County of Santa Clara

STAFF REPORT
Zoning Administration
November 4, 2021

File: PLN20-124

Design Review Approval (Tier 2) and Grading Approval for a New Single-Family Residence

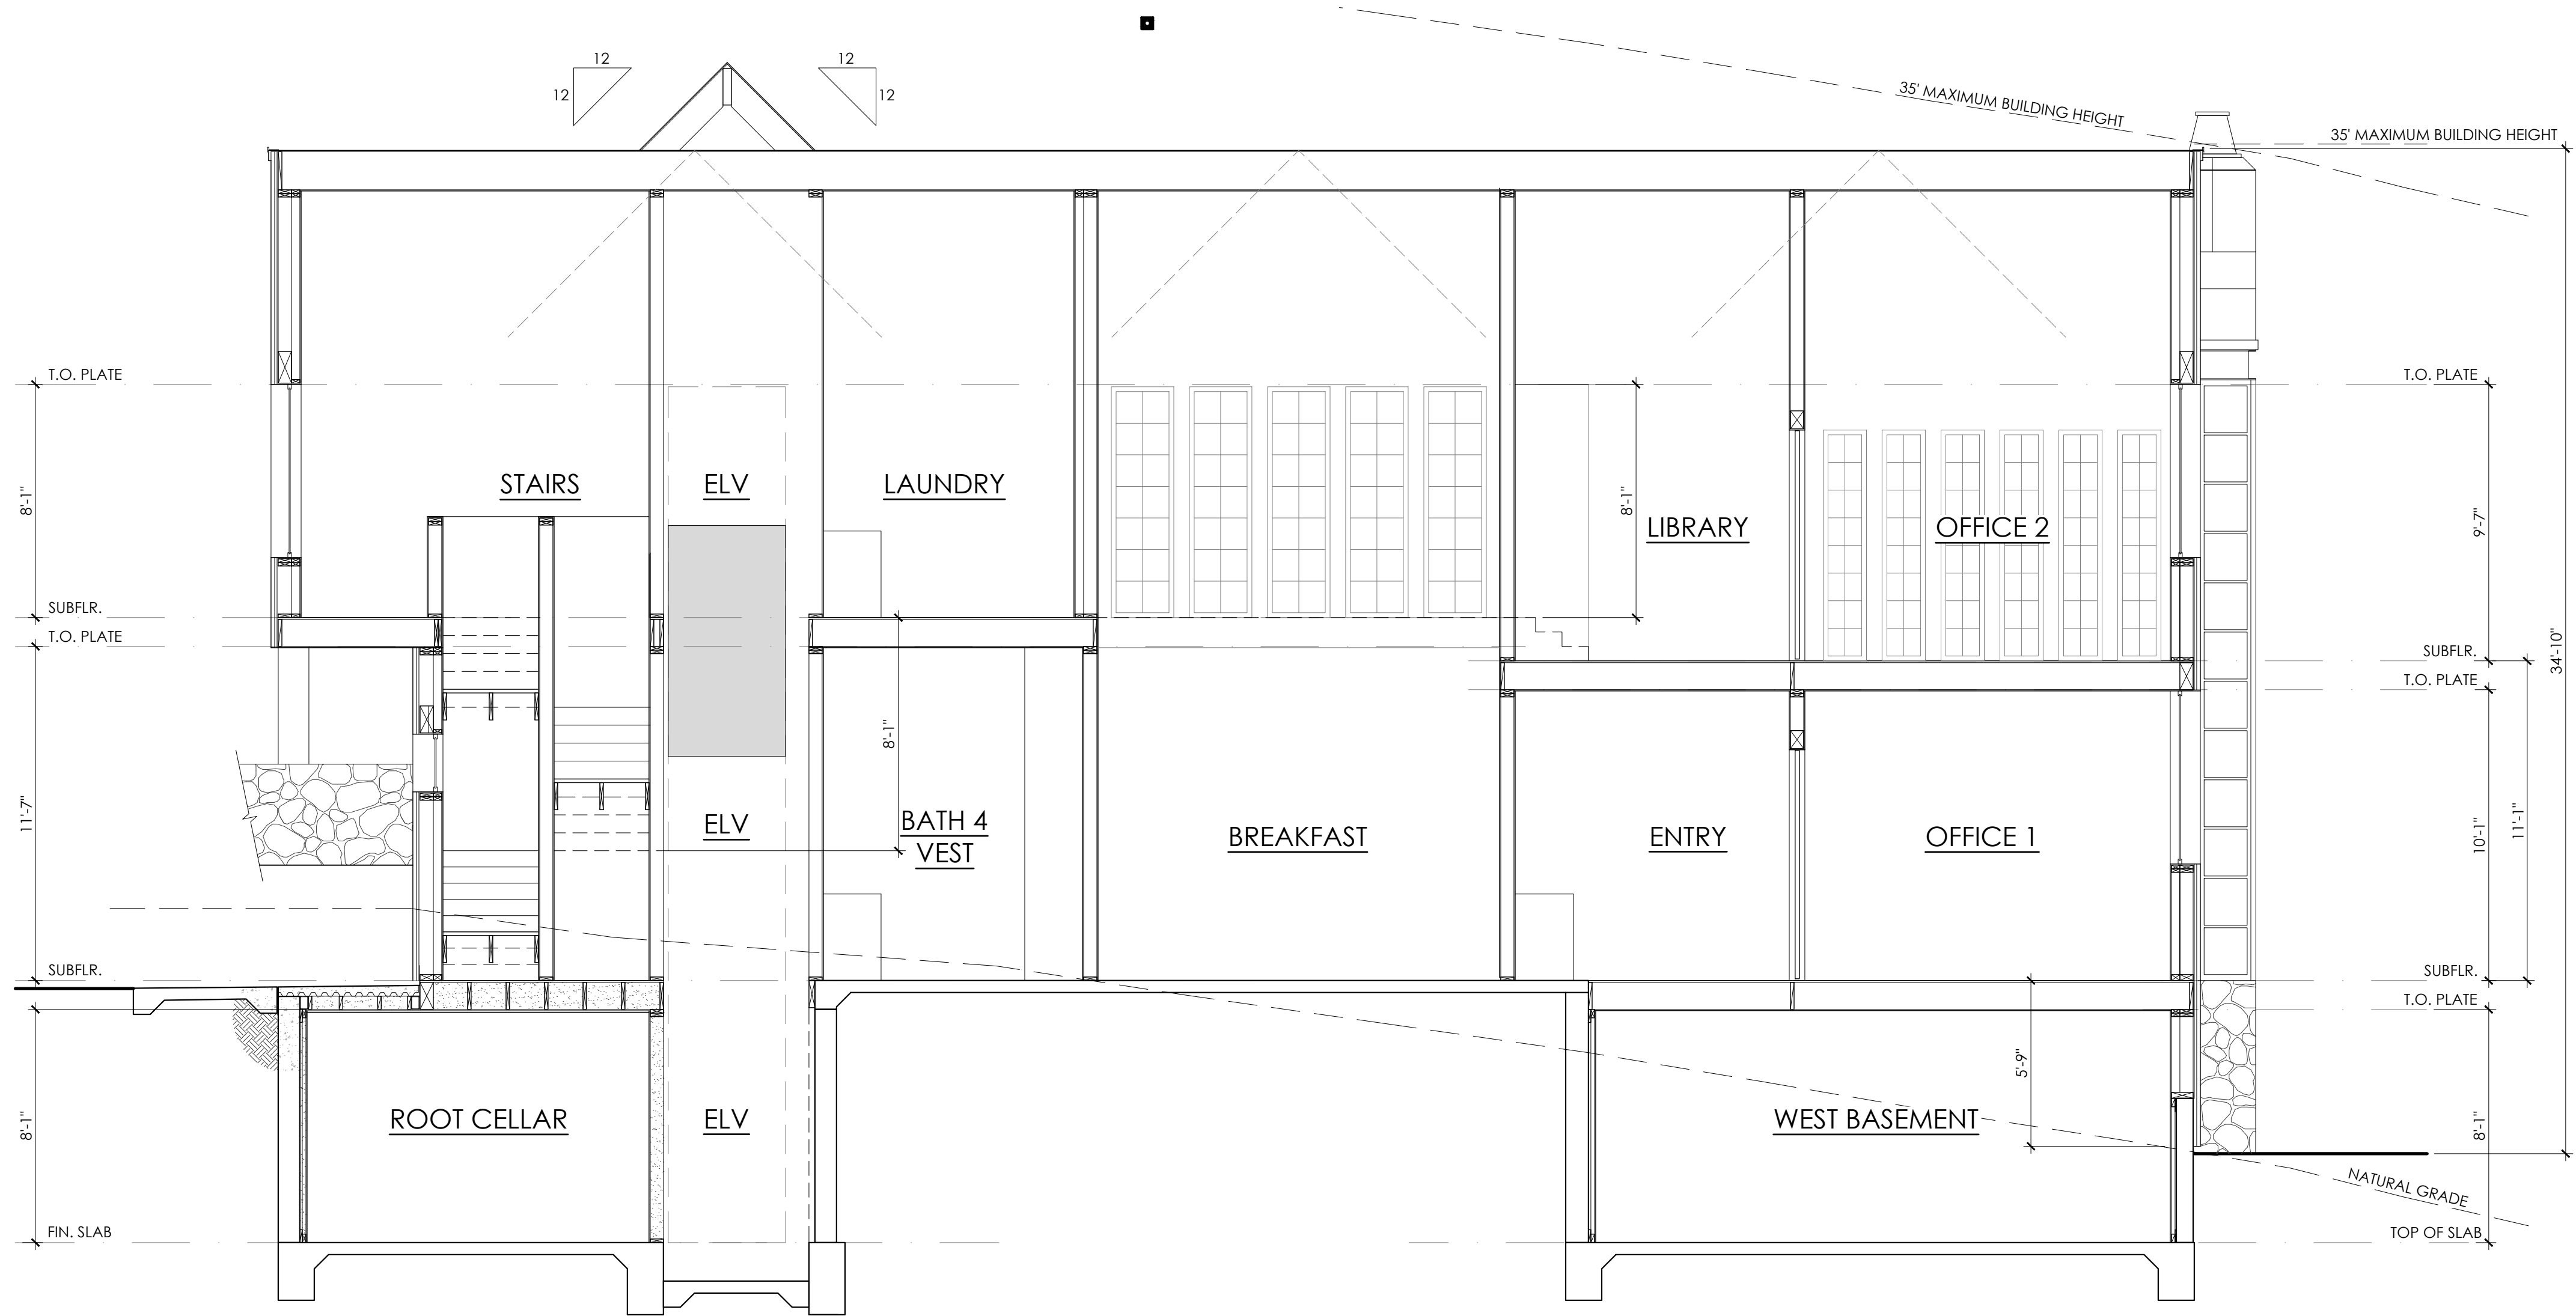
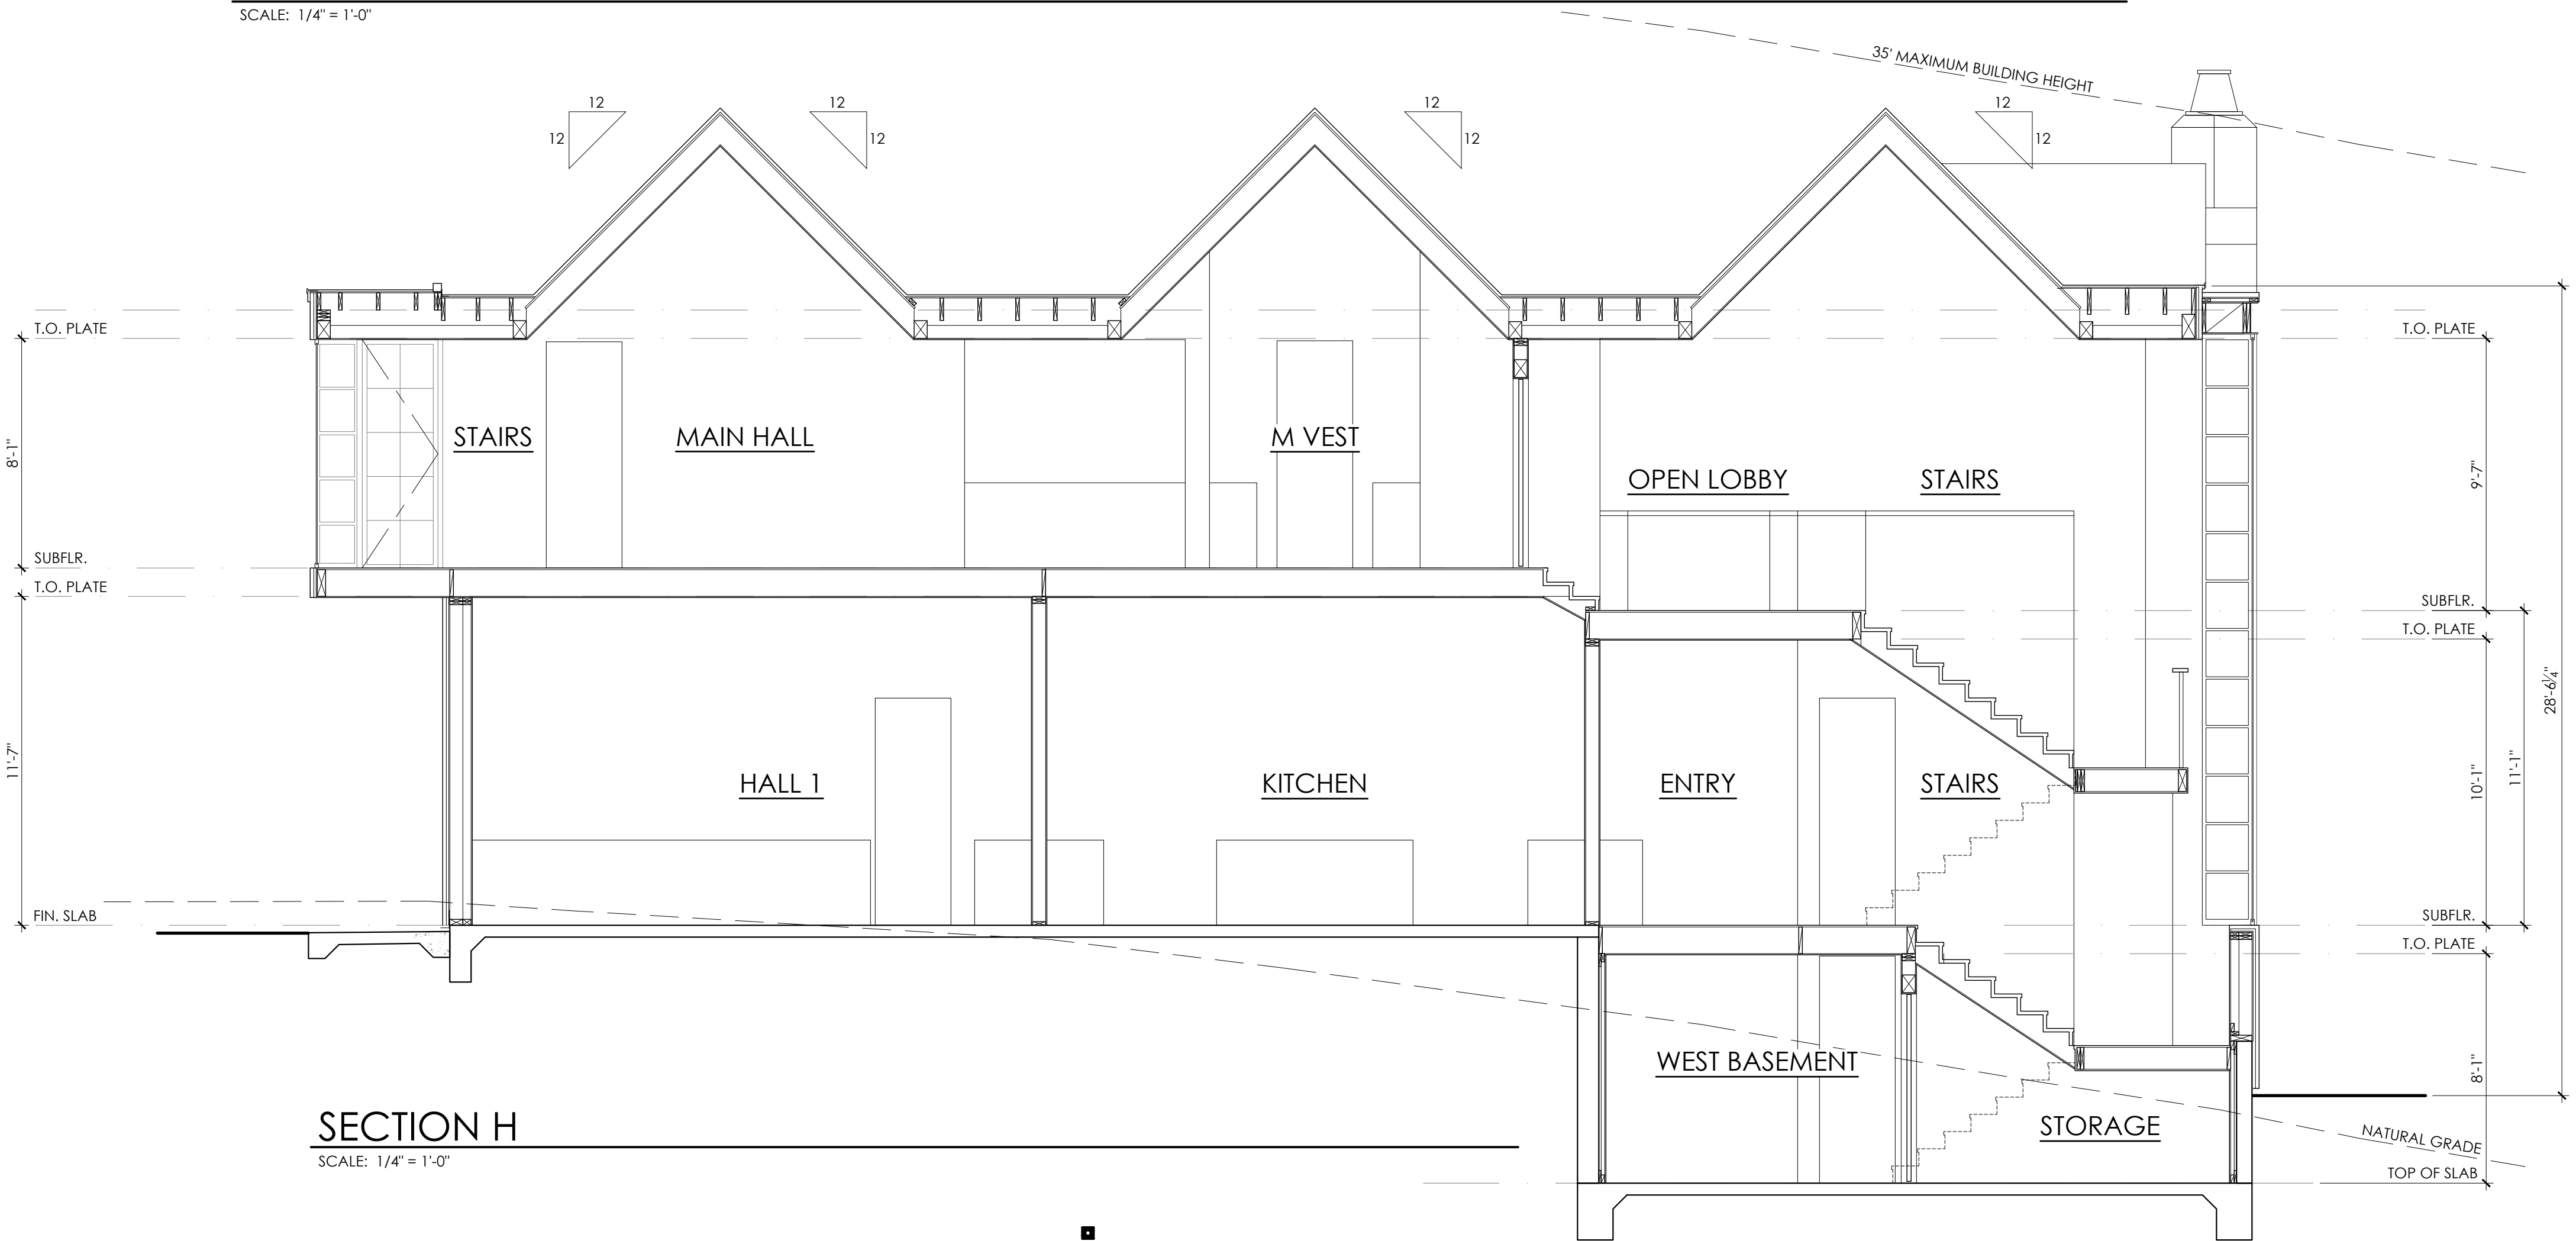
The building form does not incorporate a linear design or a tiered design approach to reduce the building massing and visual bulk, as illustrated in Section E-J (Sheet P 10.3-P10.5, Attachment C). Although portions of the building foundations utilize a stepped approach, massive roof planes are proposed at consistent heights.
